# UNITED STATES PATENT AND TRADEMARK OFFICE

| APPLICATION NO.  | FILING DATE | FIRST NAMED INVENTOR   | ATTORNEY DOCKET NO.            | CONFIRMATION NO. |
|--|-------------|------------------------|--------------------------------|------------------|
| 10/806,828   | 03/22/2004  | Svava Maria Atladottir | ACS-64880 (4171DX)             | 4223             |

### Office Action Summary

**DETAILED ACTION**

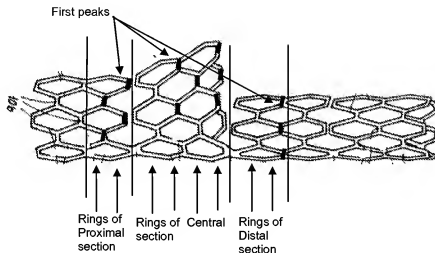
5. **Claims 1-10, 15, 38-41 are rejected under 35 U.S.C. 102(b) as being anticipated by Seguin (WO 97/46174).**
6. Seguin discloses a self-expanding stent for treating a bifurcated vessel. The stent has a plurality of rings aligned along a common axis, adjacent rings being connected by

links (9). The stent has a proximal section, distal section and central section (see below). The number of first peaks (indicated by darkened sections below) in the rings (where a ring is one undulating segment indicated below) of the central section differs from the number of first peaks in the rings of the distal and proximal sections thereby providing additional material for (capable of) apposing a side branch vessel (since the central section is larger and has more first peaks, it inherently has more material capable of apposing the side branch vessel). The first peaks of the rings of the central section are configured to (capable of) flare outward radially into an opening to the side branch vessel (see Figs. 6 and 7). The proximal section has 7 first peaks. (Since the proximal section has at least 7 first peaks including peaks on the other side of the stent that are not shown, it meets the requirement regardless of whether or not there are more than 7 first peaks. The fact that the stent may have additional structure not claimed is irrelevant. Further since the number of first peaks is selectable by the user, exactly 7 first peaks may be chosen.) The distal section has 6 first peaks and the central section has 8 peaks. The number of first peaks in the rings of the central section is greater than the number of first peaks in any of the rings of the proximal or distal sections. The central opening is offset radially from the proximal and distal openings.

15. Applicant's arguments filed 01/11/08 have been fully considered but they are not persuasive. As stated above, the number of first peaks of the central section (identified in the drawing above) is greater than the number of first peaks in the distal or proximal section and therefore it is inherent that the greater number of first peaks in the central section provides additional material that is capable of apposing a side branch vessel.
